## PLANNING STAFF REPORT

**SUBJECT:** *Kevin Cassidy Subdivision - Plan 2024-1 - Morrison Road - New Jersey - Parish of Alnwick*

**MEETING DATE:** January 23<sup>rd</sup>, 2024

**AGENDA ITEM:** 2024-1-3

# ATTACHMENT 2 - TENTATIVE SUBDIVISION PLAN

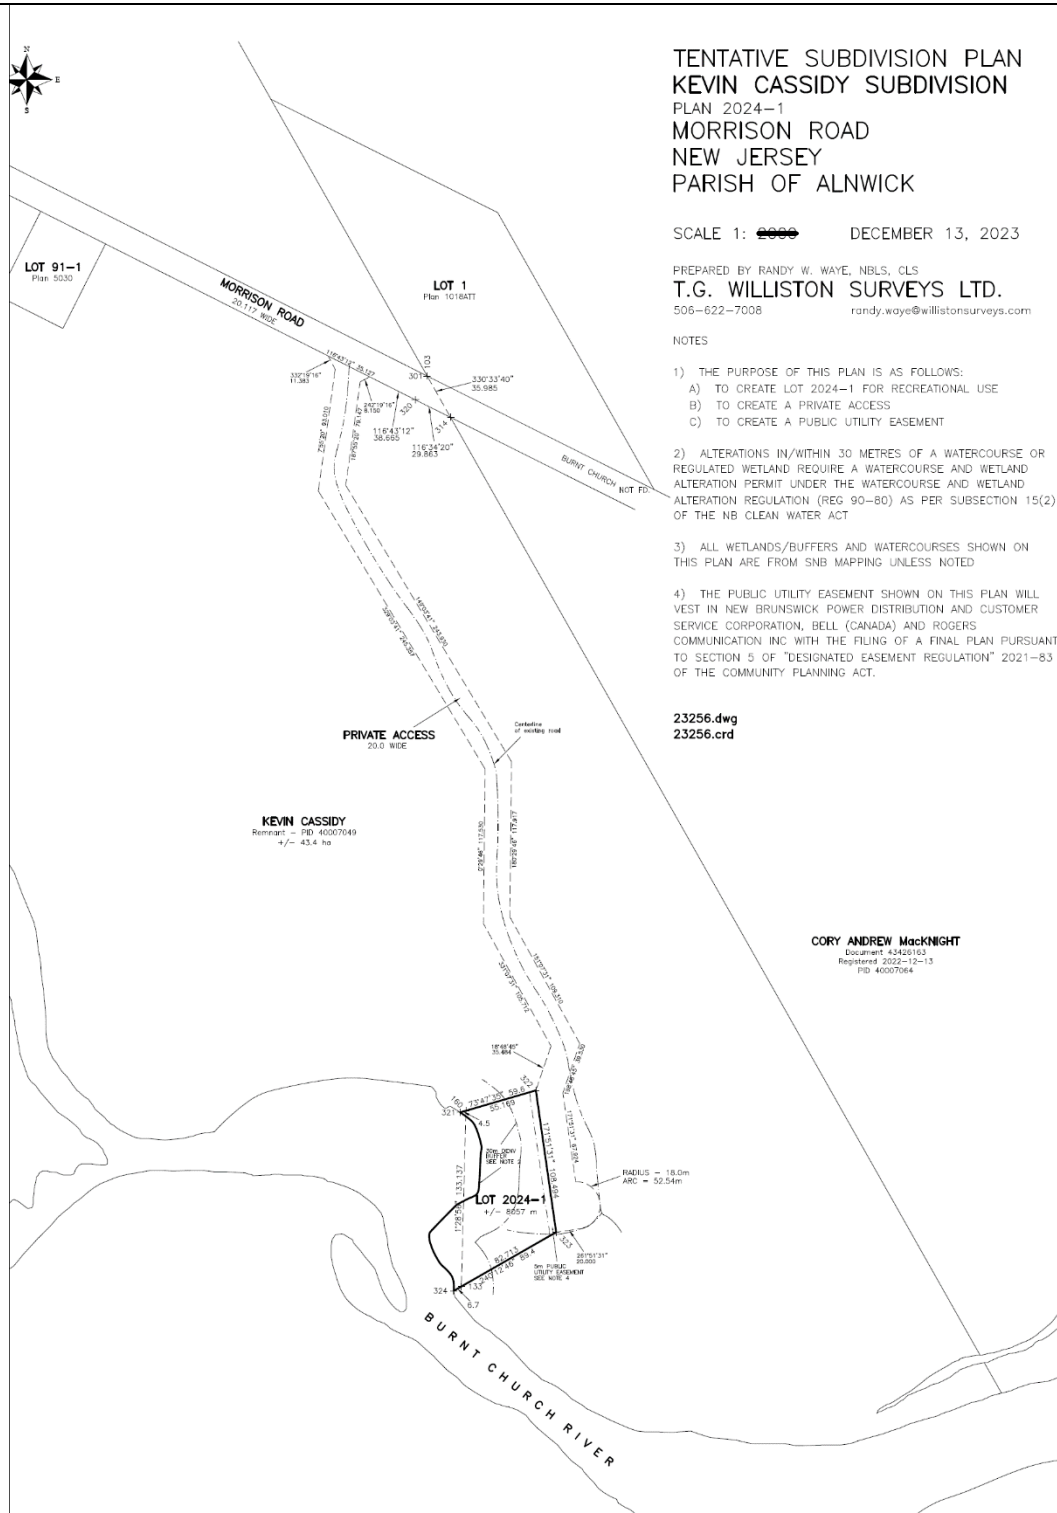
The proposed private access is required to connect Lot 2024–1 to Morrison Road, a provincially owned public road. It measures 20 metres in width, follows an existing road, and ends with an 18-metre radius turnaround as per Part B Section 1.1(f) of the GMRSC PRAC’s *Policy for Private Accesses*. The final plan will need a note mentioning that the Department of Transportation and Infrastructure (DTI) will not upgrade or maintain this private access and that the property owner is responsible to look after these. As well, the developer shall be advised that the access should be designed to support the expected loads imposed by firefighting equipment, other emergency vehicles, and private services vehicles such as for septic tank maintenance. Therefore, the access should be surfaced with concrete, asphalt or other material designed to permit accessibility under all climatic conditions.

A subdivision inspection report (sight distance) is not necessary given the existence of the road already accessing Morrison Road (*Minimum Standards for the Construction of Subdivision Roads and Streets*, Appendix A, table A11.1). The surface of this section of Morrison Road is paved and maintained by DTI.

The proposed lot meets the required width, depth, and area minimums as per Section 6(4) of the New Brunswick Regulation 80-159 under the *Community Planning Act* (c.19). A subdivision assessment report (soil test) will not be required as the lot measures just over 8,050 square metres (*New Brunswick Technical Guidelines for On-site Sewage Disposal Systems*, Appendices B and B1). The remnant of PID 40007049 retains an area of about 43.4 hectares. Although the private access will fragment the remnant in two portions, both would be big enough to potentially be subdivided in the future.

Other than the Burnt Church River, the hydrographic network webmapping from the Department of Natural Resources and Energy Development (DNRED) identifies no presence of watercourses on the lot. The wetland webmapping from the Department of Environment and Local Government (DELG) shows presence of wetland just outside of the proposed lot. Consequently, any alteration to the property may require a Watercourse and Wetland Alteration permit from the DELG or a permit from the GMRSC.

As per Section 6(1) of the New Brunswick Regulation 80-159 under the *Community Planning Act* (c.19), it is recommended that the Planning Review and Adjustment Committee (PRAC) of the Greater Miramichi Regional Service Commission approves *Kevin Cassidy Subdivision - Plan 2024–1 - Morrison Road - New Jersey - Parish of Alnwick* provided that the following notes be inserted on the final plan:

“The private access shown on this plan is not suitable for a public street. The Department of Transportation and Infrastructure will not upgrade or maintain this private access and all maintenance services and improvements to the private access are the responsibility of the property owner”; and

“The Planning Review and Adjustment Committee (PRAC) does not carry on-site inspections of the private access shown on this plan. Construction of a private access on this parcel of land in accordance with all relevant regulations, if any, is the strict and sole responsibility of the property owner or developer. The PRAC expressly makes neither representations nor warranties of any nature whatsoever that the condition and construction of the access is suitable for safe movement of vehicle traffic. The PRAC only approves the location of the access shown on this plan and not its condition and makes no representation nor warranties whatsoever with respect to the condition of the access.”
